Energy Efficient ECM Circulators Now Ship with Select Residential Boilers

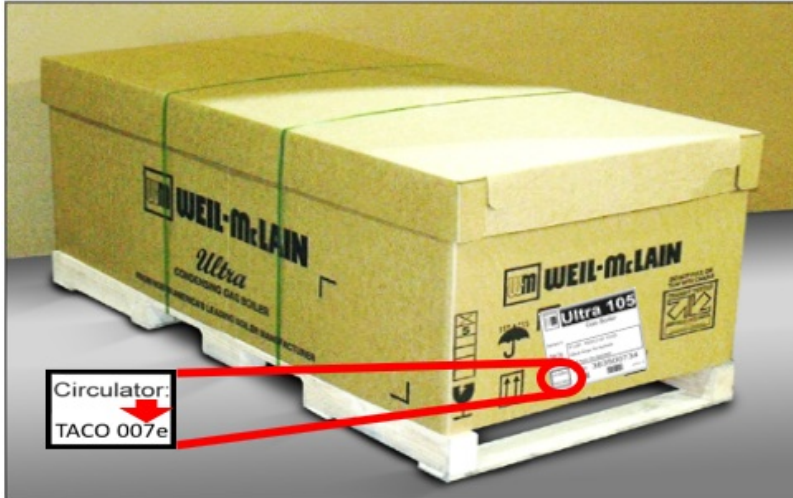
Another way to determine if a 007e ECM circulator is included with the boiler, the boiler shipping carton label changed on all affected units, per the image below.
